SUBJECT: **NEW VEHICLE DEMONSTRATION / DELIVERY HOLD**
Safety Recall 21S53 - Supplement #3
Certain 2018 Model Year F-150 built at Dearborn Assembly
Tailgate Latch Replacement

New! REASON FOR THIS SUPPLEMENT

- **Labor Allowances:** Labor operation code correction.

FIGURE 1

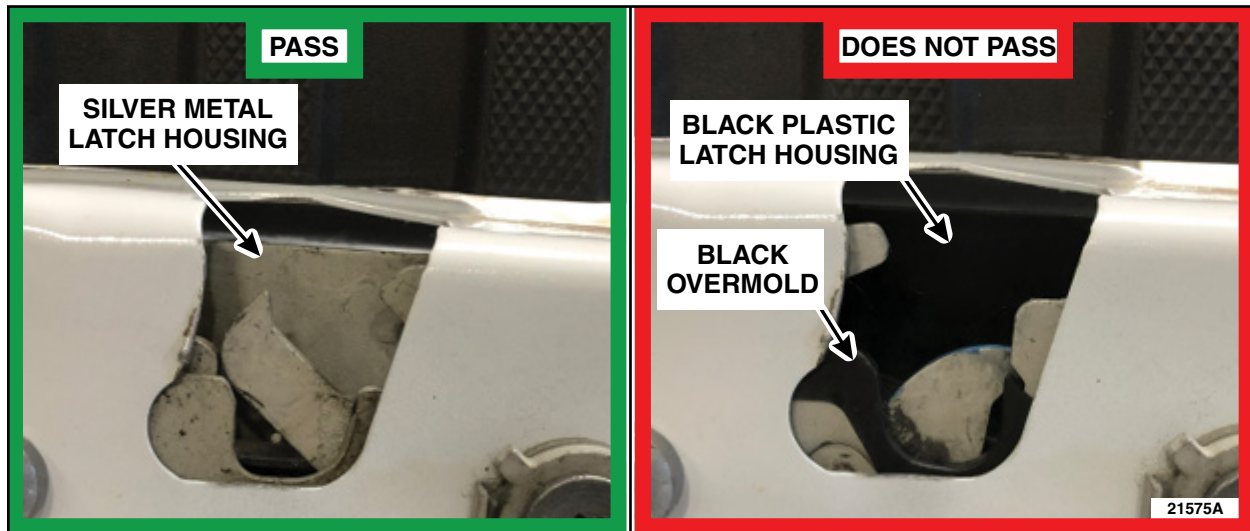
1. Lower the tailgate and inspect both latches for either a black plastic latch housing or a silver metal latch housing. See Figure 1. The black plastic housing is not to be confused with any bed liner over spray. See Figure 2.

PASS - Both latches have a silver metal housing and does not require replacement. This completes the recall.

DOES NOT PASS - Either latch has a black plastic housing and requires replacement. Replace the affected latch(es) by following the Workshop Manual (WSM) procedures in Section 501-14.
